## ADDENDUM

**PROJECT:** Crawford County Memorial Hospital  
MRI Infill  
Denison, Iowa

AD-1

**DATE ISSUED:** Friday, December 16, 2011

**2 Partial New Plan - Electrical**

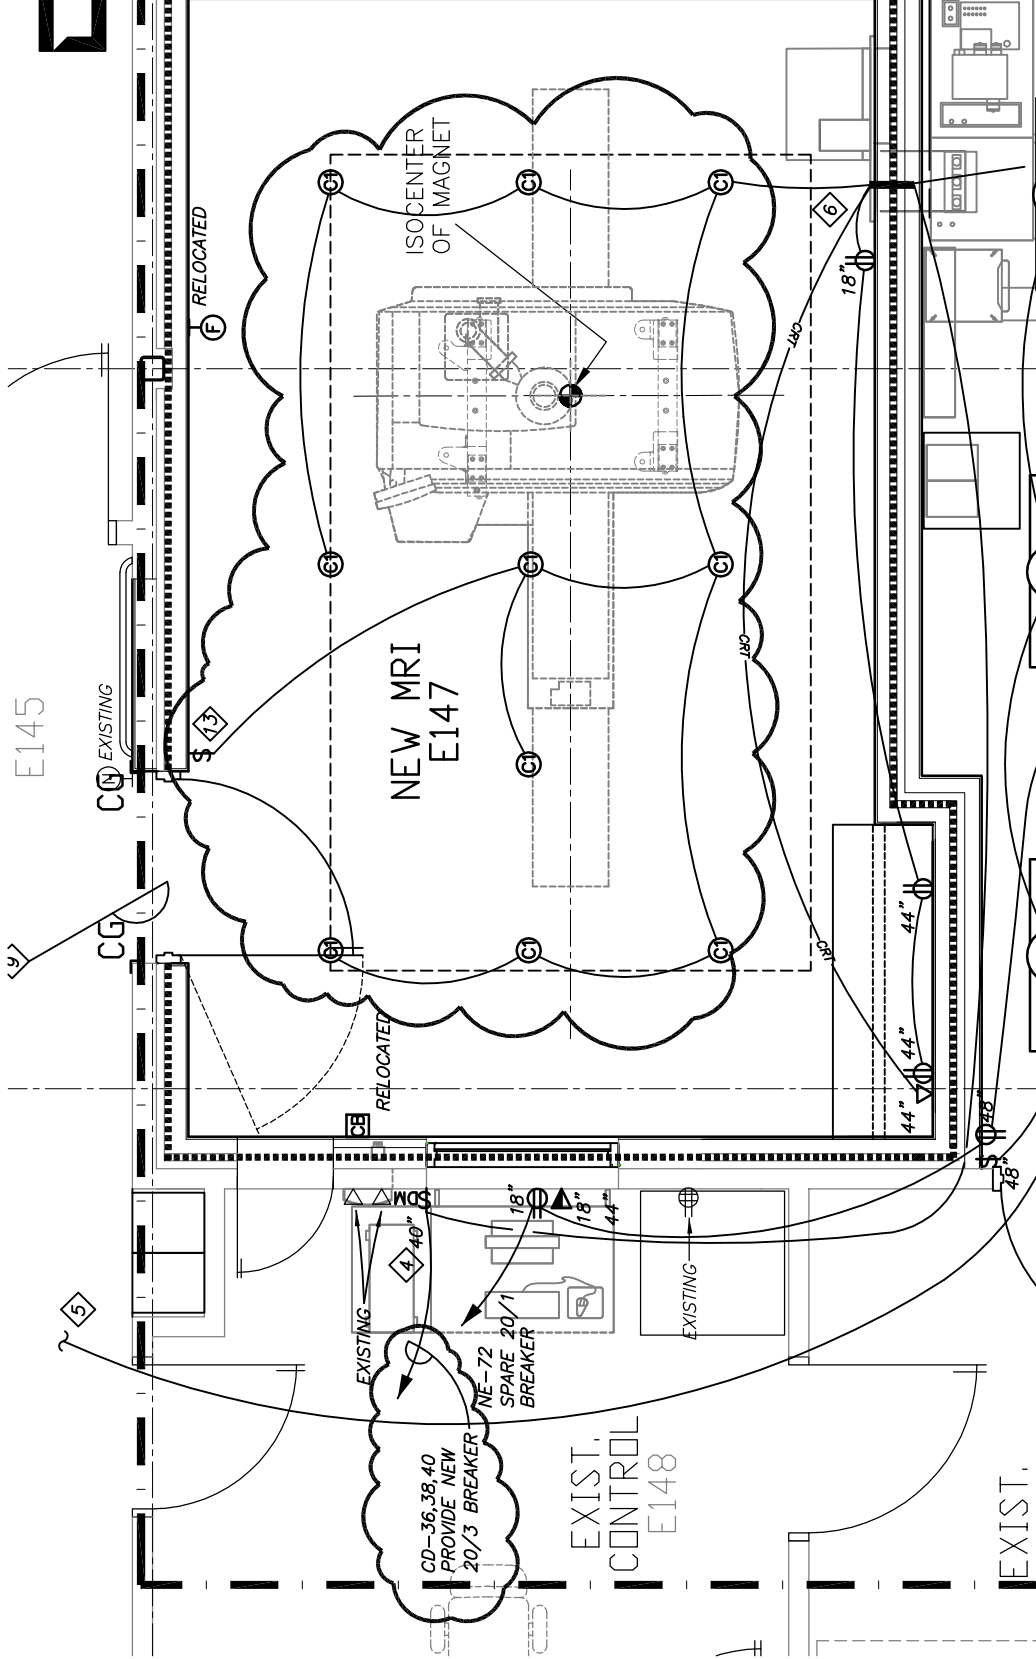
In reference to drawing Sheet E-101-E – Plan 2, see attached Supplement Drawing E-101-E-1 for changes in light switching and keynotes.

**ELECTRICAL PLAN  
KEYED NOTES:**

- 4 PROVIDE LEVITON OR EQUAL #82000, 2000W INCANDESCENT DIMMER. SWITCH TO BE DC RATED ALSO. COORDINATE COLOR OF DEVICE WITH EXISTING DEVICES IN HOSPITAL PRIOR TO ORDERING.
- 5 SEE SIEMENS MRI DRAWINGS FOR ADDITIONAL ELECTRICAL WORK. ON SIEMENS DRAWINGS WHEN EQUIPMENT OR WORK IS CALLED OUT BY EITHER CUSTOMER/CONTRACTOR OR CUSTOMER, THESE ITEMS WILL BE DONE BY THE ELECTRICAL CONTRACTOR. PROVIDE AC TO DC LIGHTING CONVERTER FOR MRI ROOM LIGHTS. COORDINATE BID QUESTIONS AND MRI WORK WITH DAVE ENGDALH. TELEPHONE NUMBER 1-402-960-7283, VOICE MESSAGE NUMBER 1-800-228-5462 (EXT. 1263), E-MAIL ADDRESS dengdahh@cassling.com.
- 6 PROVIDE LEVITON OR EQUAL #CSB1-20. SWITCH TO CONTROL LIGHTS OVER BED PART OF MRI. SWITCH TO BE DC RATED ALSO. COORDINATE COLOR OF DEVICE WITH EXISTING DEVICES IN HOSPITAL PRIOR TO ORDERING.
- 9
